YG-DCO-126

Yorkshire Green Energy Enablement (GREEN) Project

**Document 8.24 Applicant's Comments on Interested Parties' Deadline
4 Submissions**

**Final Issue A
July 2023**

Appendix A Illustrative Plan: Access during construction phase – Shipton

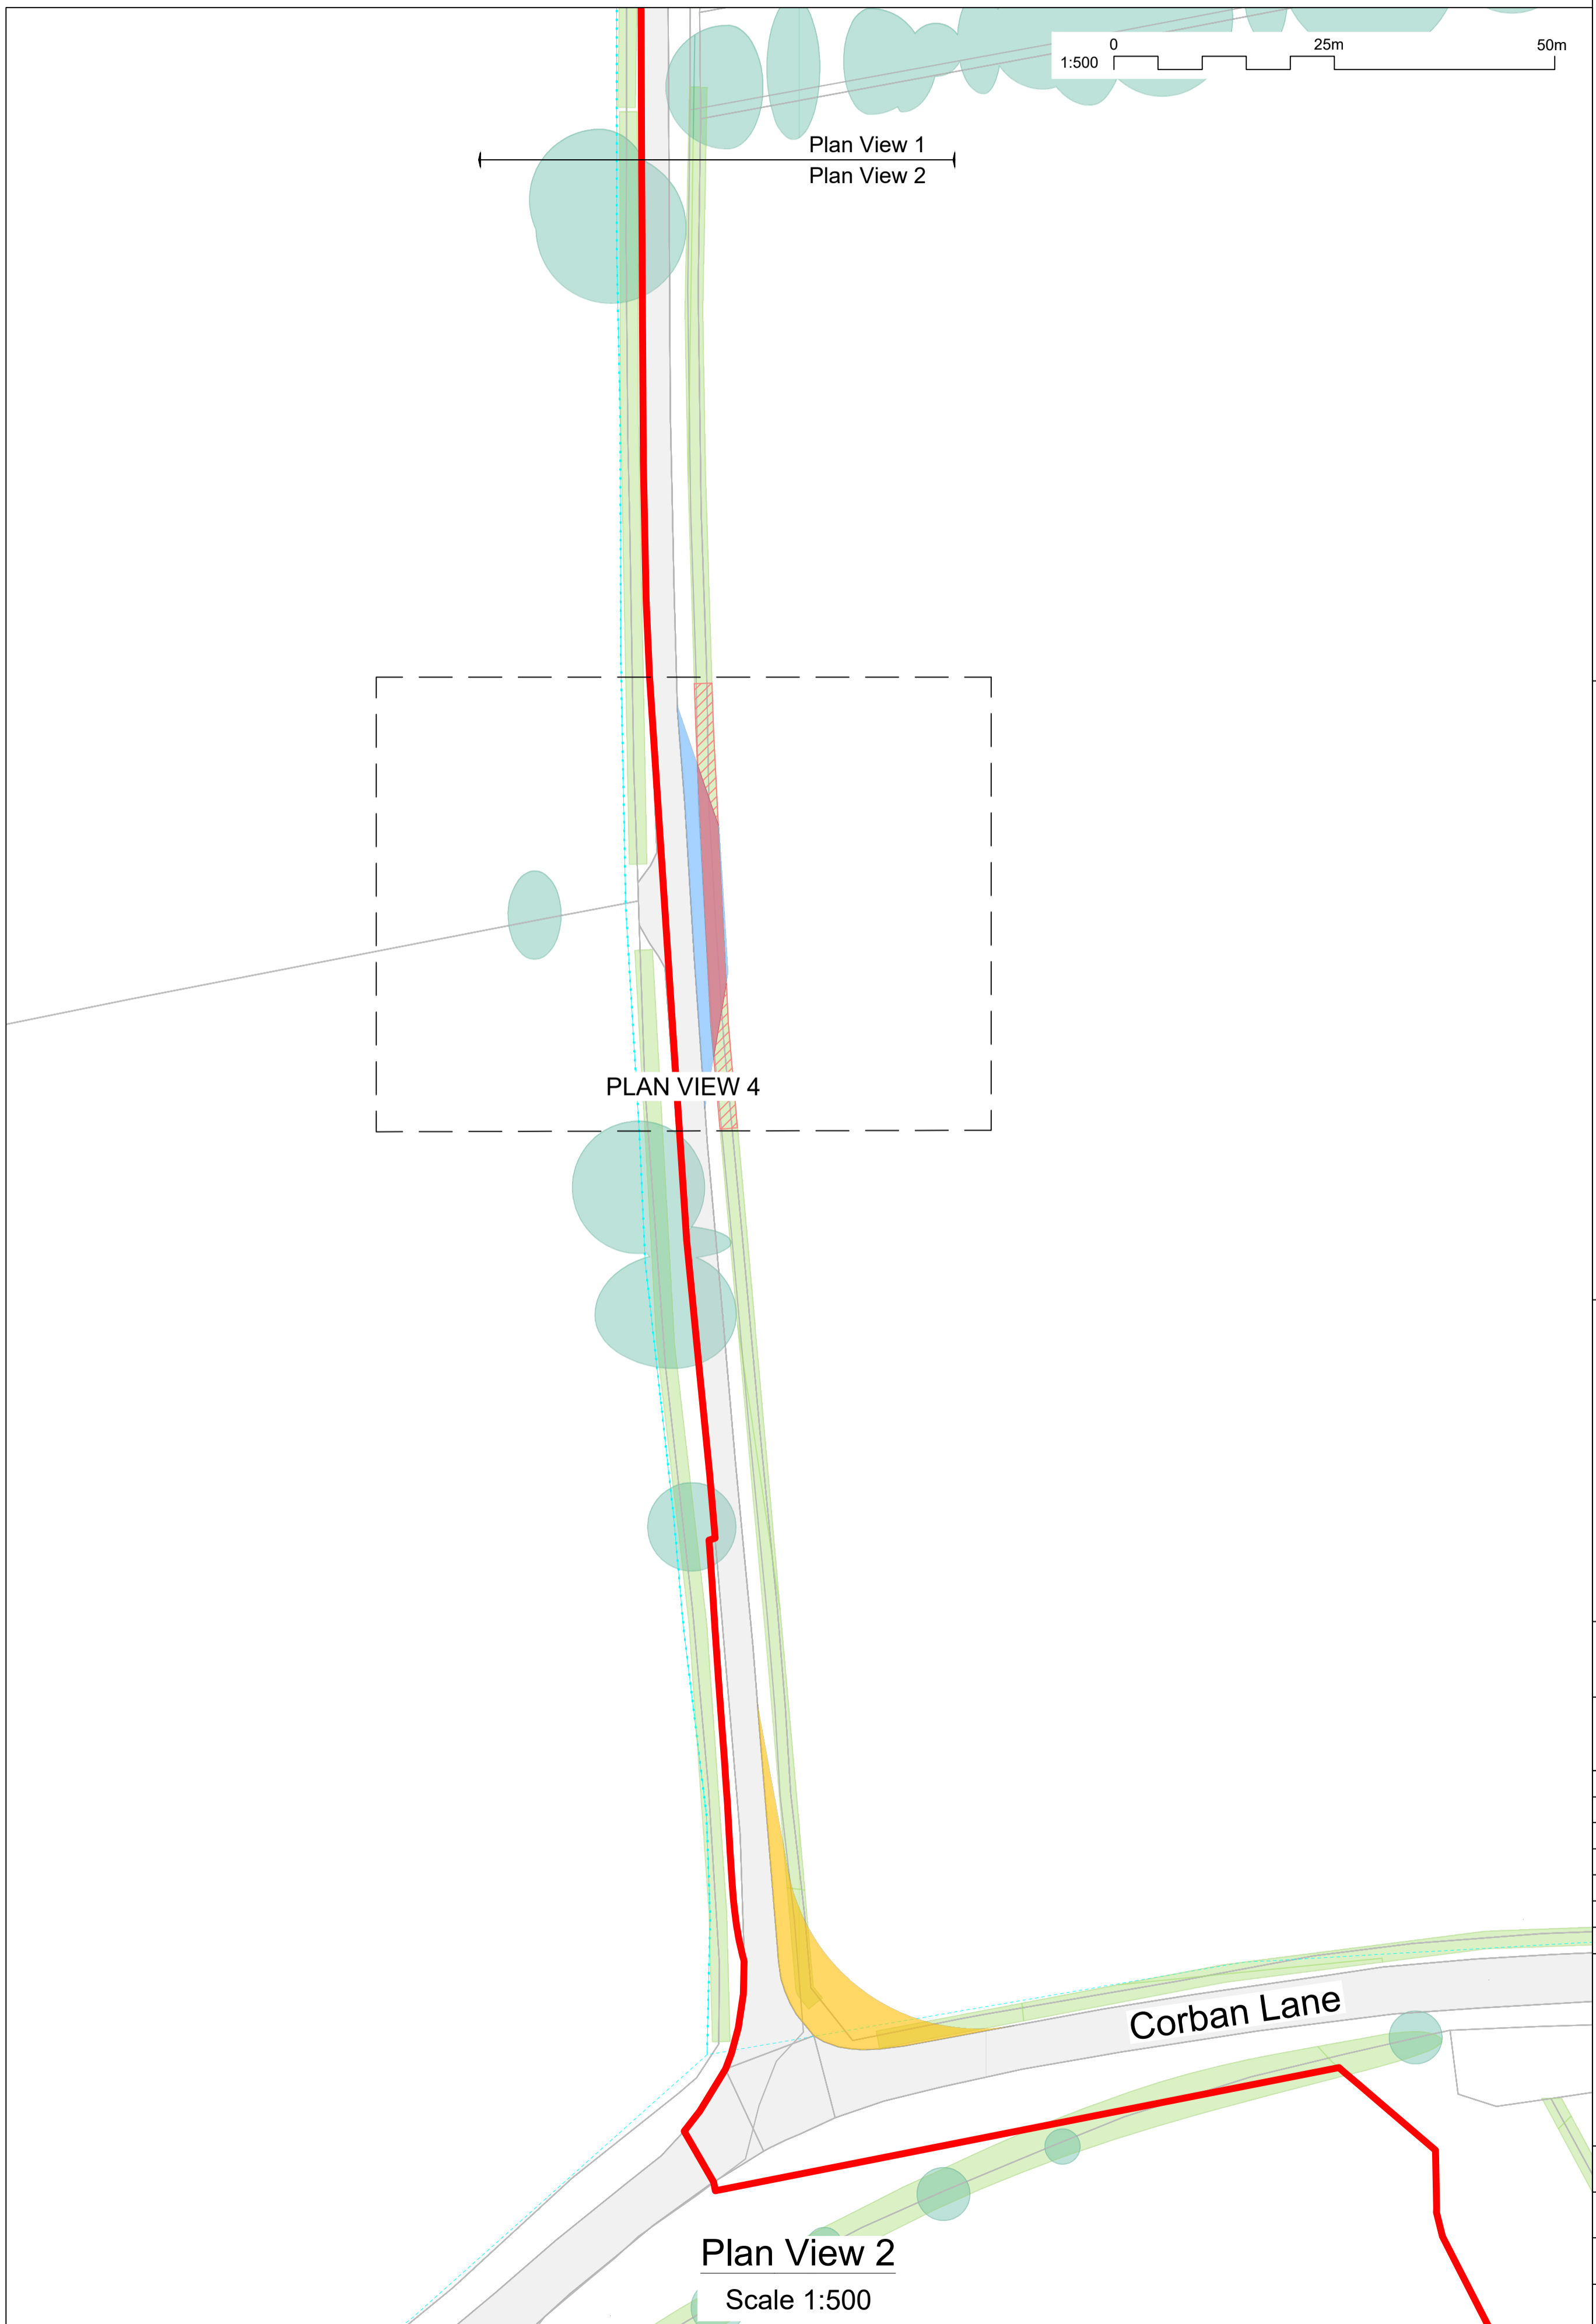
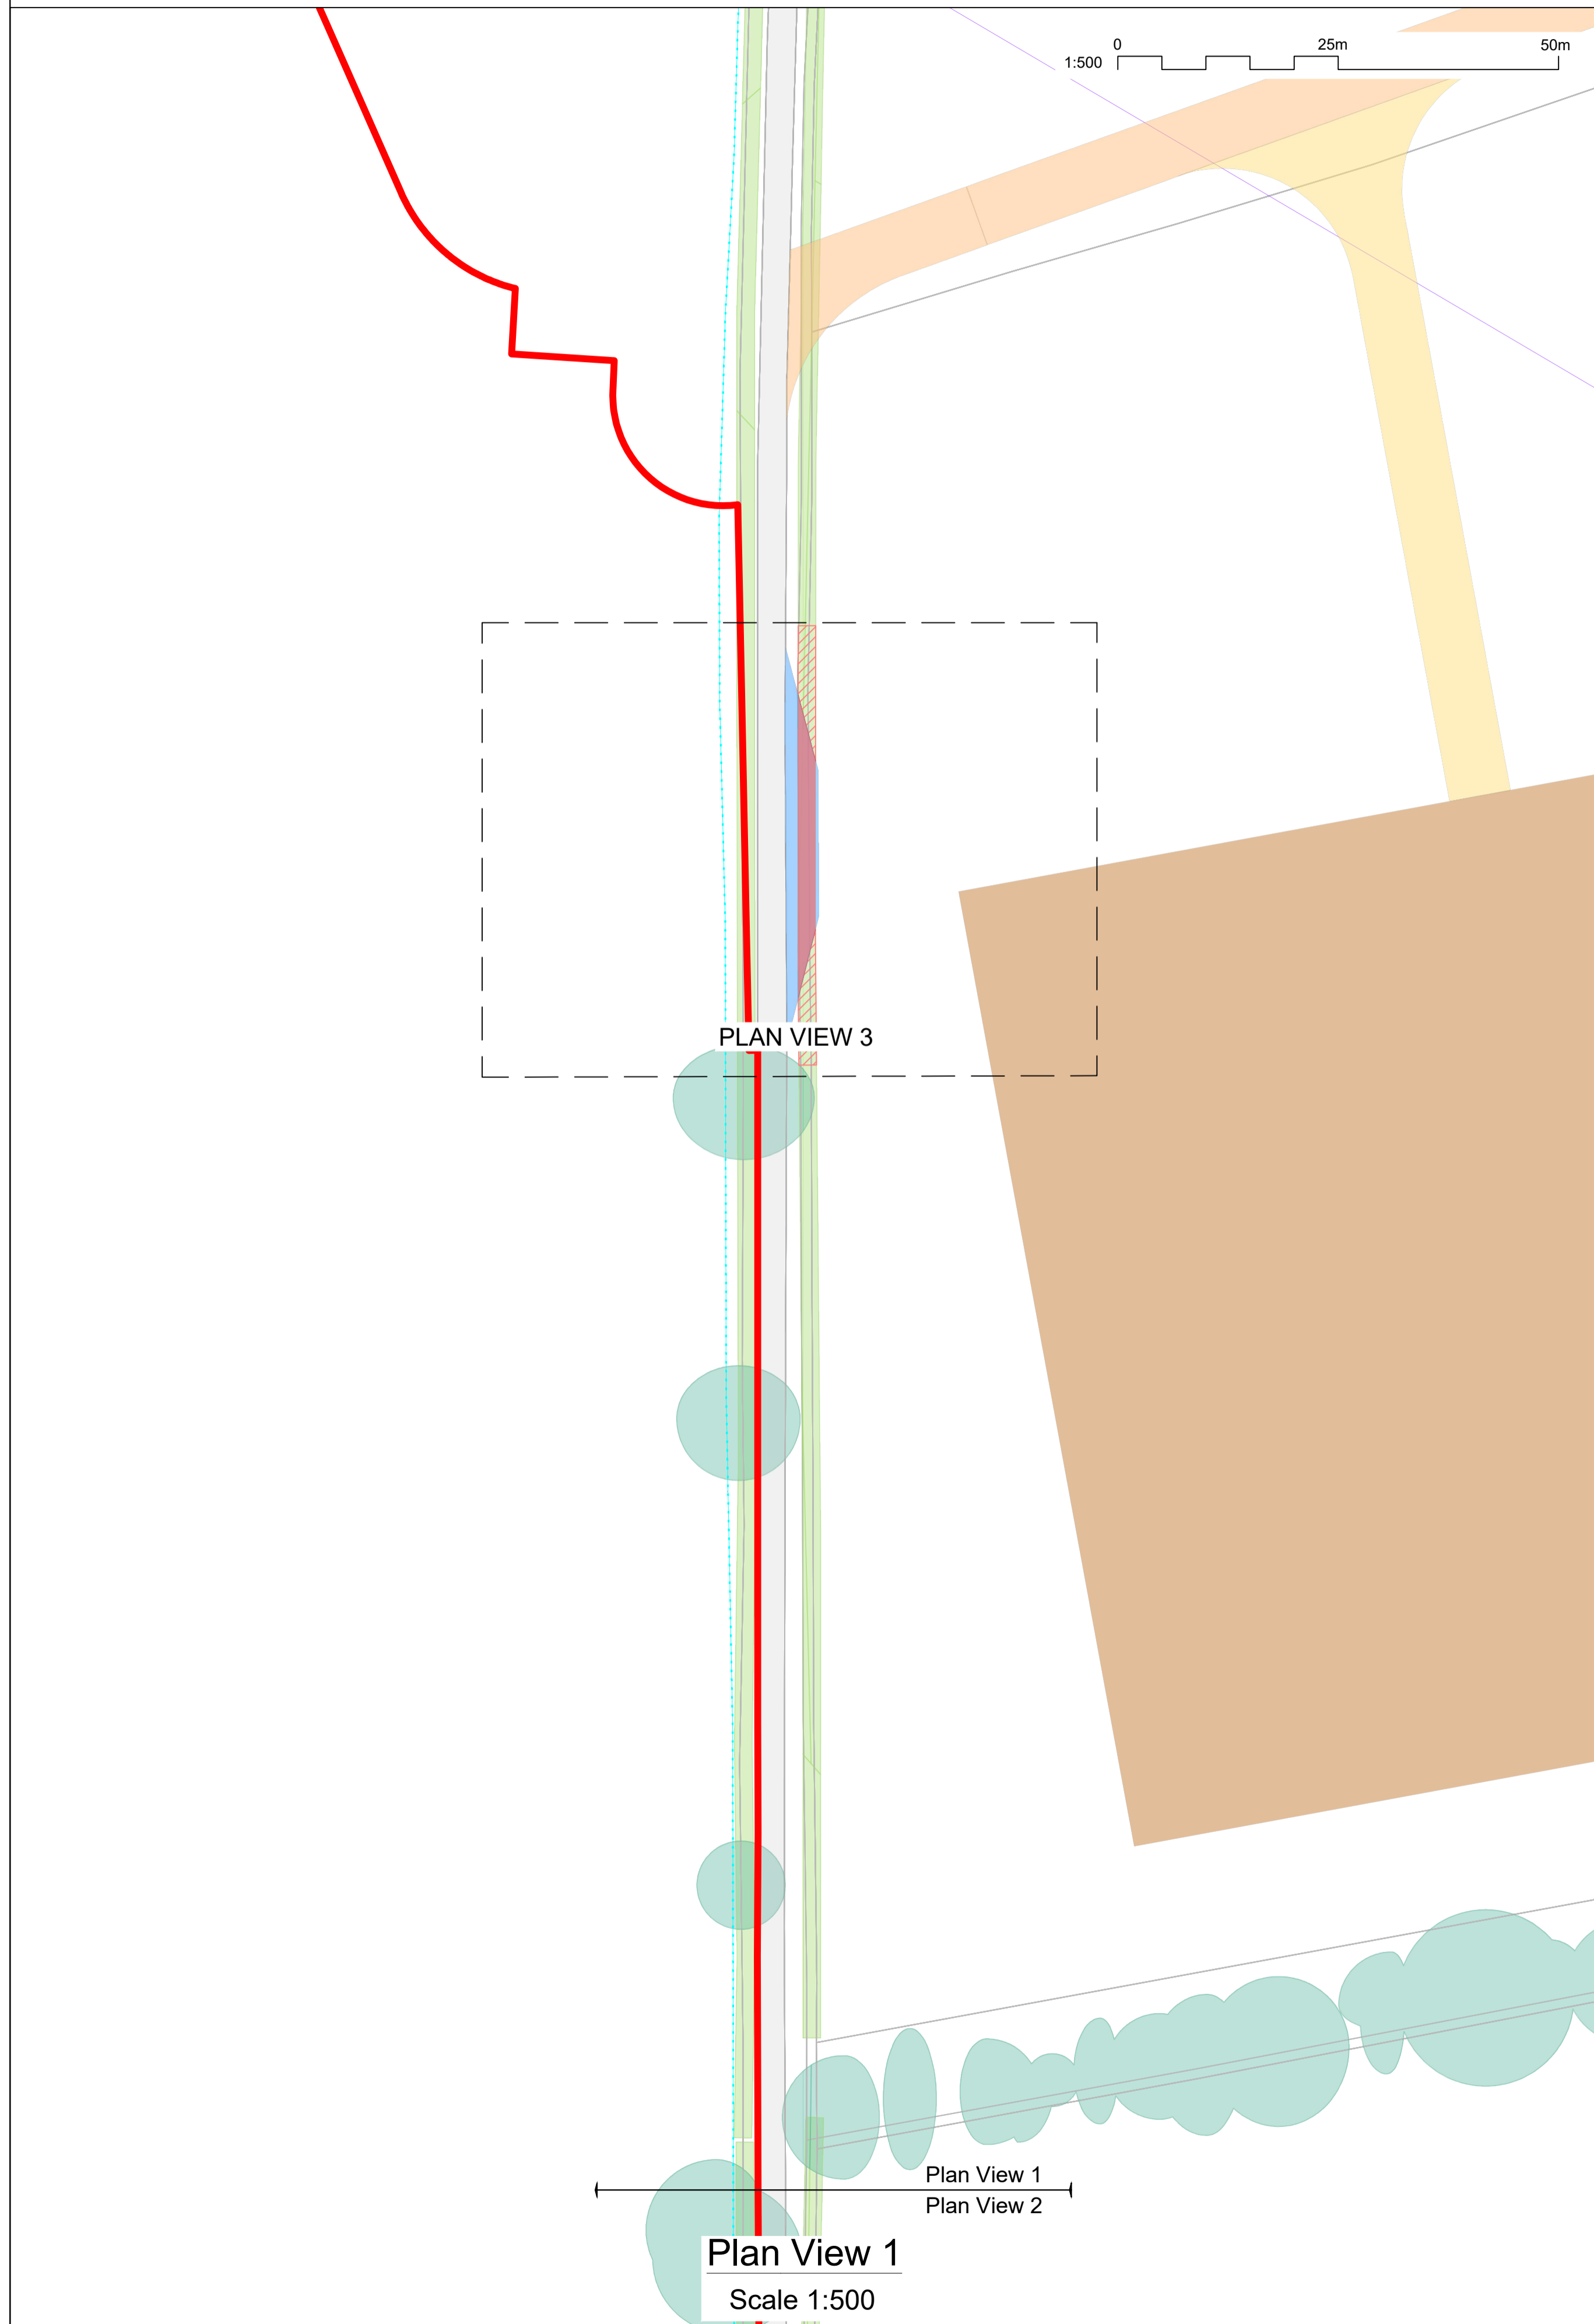
Reference	Topic	Applicant's Response
Action Point 22	Request for a meeting	National Grid met with Mr Stephenson and his clients on Friday 16 June 2023.
Action Point 30	Construction traffic and proposed alternative access.	a) National Grid note the deliveries required for the farming operations, and National Grid will manage the construction traffic to seek to minimise the impact on deliveries during the construction phase. This will be undertaken by the installation of passing places along the public

Reference	Topic	Applicant's Response
		<p>highway, which provide additional passing places to those provided in the bellmouths to be installed, as well as coordination with the Agricultural Liaison Officer (ALO), as set out in the Code of Construction Practice (Document 5.3.3B(C)) and the Traffic Coordination Officer (TCO) as set out in the Construction Traffic Management Plan (Document 5.3.3F (B)) submitted at Deadline 5. To aid understanding National Grid have submitted an illustration of what the road could look like with passing places shown (this is for illustration purposes only, and may vary a during detailed design), in Appendix A of this document.</p> <p>b) 25,525 vehicle movements (two way) shown in Appendix 12A Traffic Modelling Tables (Document 5.3.12A [APP-148]) are indicated for Access Points (AP) 95, 96, 97, 98 and 99. 12,858 of these movements will be to access point 95, which is on the junction of Corban Lane, with HGV movements coming from the east on Corban Lane turning right into this bellmouth, therefore will not be travelling further up Newlands Lane.</p> <ul style="list-style-type: none"> i. National Grid are not proposing to double the size of the road for the construction period as it is not necessary, suitable passing places will be included along the lane during the construction period. ii. National Grid are proposing to construct passing places to allow construction and farm traffic to pass on the lane. National Grid are awaiting the submission of a sketch of what suitable passing places would look like from Mr. Stephenson's the land agents and his clients point of view but have produced the above referenced illustration as this information has not yet been provided. iii. National Grid are not proposing a connecting road between the two construction compounds. The construction compounds are for use by separate contractors (overhead line contractor and CSEC contractor) and have separate access points, AP95 for the southern compound and AP98 for the northern compound.

Reference	Topic	Applicant's Response
		<p>Constructing a road between the two compounds would involve an additional stone access track and the removal of an additional amount of tress on the boundary between the two different land holdings which is not required. This change would also move the access onto another party's land. National Grid do not believe this isrequired, with traffic being managed along the lane, and passing places, and bellmouths being installed.</p>
